PWB ARTWORK REVISIONS

E0445H

ENERPRO	
SCHEMATIC DIAGRAM: VARIABLE FREQUENCY 3-PHASE FIRING CIRCUIT	
redwn: fjb	02-15-06
ver: fjb	02-23-07
	11-08-07
PCB PN FCOVF6100	E0445H
SIZE: B	SHEET 1 OF 2

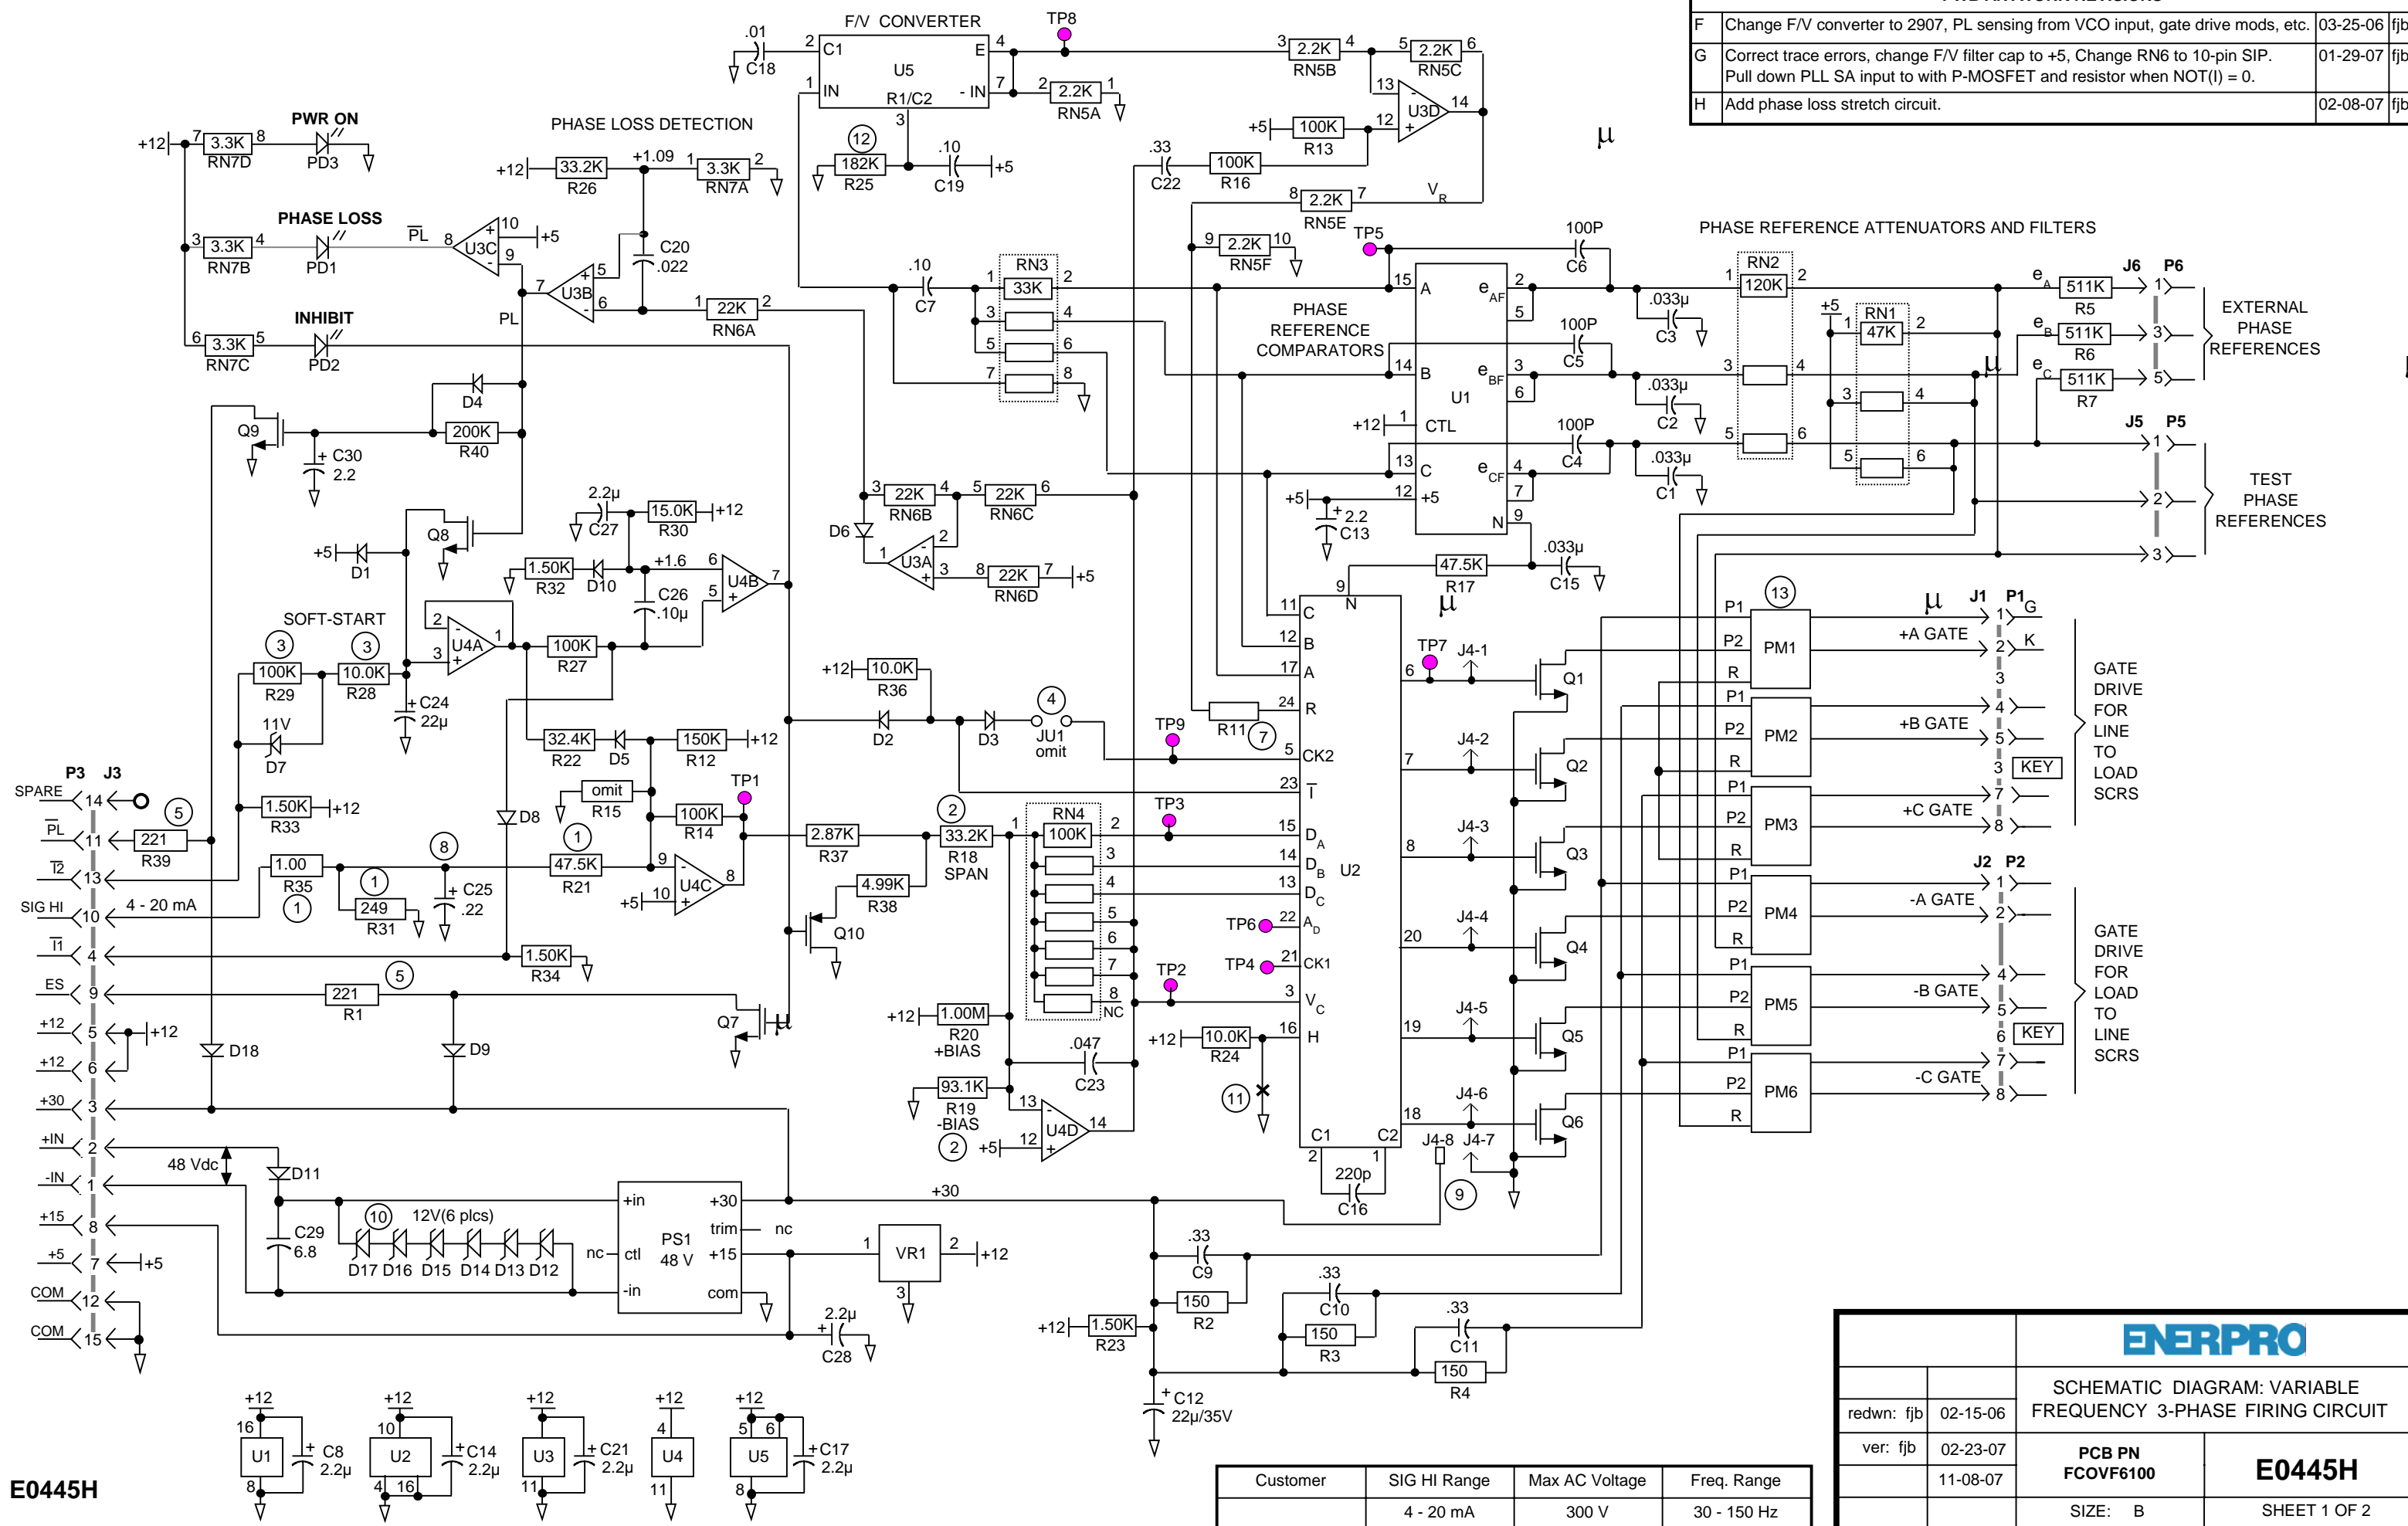
F	Change F/V converter to 2907, PL sensing from VCO input, gate drive mods, etc.	03-25-06	fjb
G	Correct trace errors, change F/V filter cap to +5, Change RN6 to 10-pin SIP.	01-29-07	fjb
H	Add phase loss stretch circuit.	02-08-07	fjb

CHANGE RECORD					
DATE	PCB REV.	BY	CHANGE	REASON FOR CHANGE	
03-07-06	F	fjb	1. Re-draw in SmartDraw. 2. Change the F/V converter circuit from 555 to 2907 type. 3. Change phase loss sensing from comparator operating on filtered sum of phase references to comparator operating on VCO control voltage. 4. Add hysteresis capacitors to phase reference comparators. 5. Change gate drive transistors from ULN2005 IC to individual MOSFETs. 6. Increase spacing between the three gate drive current limiting resistors. 7. Eliminate the single 10 gate current limiting resistor. 8. Change the number of shunt regulator zeners from five to six. 9. Removed C31 and RN4E. Changed RN4 from 10-pos. to 8-pos. SIP.	1. Replace original McDraw format. 2. Increase the F/V converter ripple frequency from 3F to 6F. 3. Make phase loss sensor sensitivity independent of frequency. 4. Improve phase reference comparator noise immunity. 5. Increase drive current capability. 6. Allow reduced resistance and increased gate current. 7. Increase gate current. 8. Increase the shunt regulator current capability.

08-29-06	G	fjb	1. Change RN6 from 8-pos. to 10-pos. SIP. 2. Change R16 from 76.8 K to 221 K. 3. Remove trace from RN6 to J3-14. 4. Rename R38 as R17, R39 as R18. 5. Change C25 from 680 p to 220 p. 6. Add resistor and trace cut designation to H signal.	1. Make F/V circuit same as on FCOVFS31 board, eliminate 2 resistors. 2. Required due to change #1. 3. Required due to change #1. 4. Permitted due to change #1 5. Because of increased max frequency. 6. When ac supply frequency is greater than 500 Hz.	
01-30-07	G	fjb	1. Change C7 from 2.2 uF to .10 uF 2. Change C12 from 6.8 uF to .33 uF, omit C13, Renumber C14-C30 as C13-C29. 3. Add Q9, R39 and R40 to reduce input voltage to PLL summing amplifier when gating is inhibited. 4. Add 50% voltage divider between J3-10 and R28. 5. Change D16 to 11 V 500 mW zener. 6. Remove zener D7, renumber D8 to D16 as D7 to D15, change D2-D6 to 6.2 V zener. 7. Change phase loss filter cap C25 from .10 uf to .022 uf. 8. Add transistor to drive phase loss indicating relay, change Q7 to BS170. 9. Change relay interface resistors R42 and R43 from 3 W to .25 W.	1. Reduce F/V converter delay. 2. Large capacitance not needed with NFC20-24D15 dc-dc converter. 3. Ensure PLL is in lock before gating is enabled. 4. Allow 0-5V or 0-10 VSIG HI range with no change in buffer amp bias resistors. 5. Reduce enable delay. 6. Revert to original 5 zener design. 7. Improve reliability of phase loss sensing. 8. PL transistor per customer request. 9. Save board space.

02-08-07	H	fjb	1. Add R40, C30 and D4 phase loss stretch circuit.	1. Prevent chatter in customer's phase loss relay.	
11-08-07	H	drs	1. Corrected a schematic error: resistor R5 changed to R7 and R7 changed to R5.
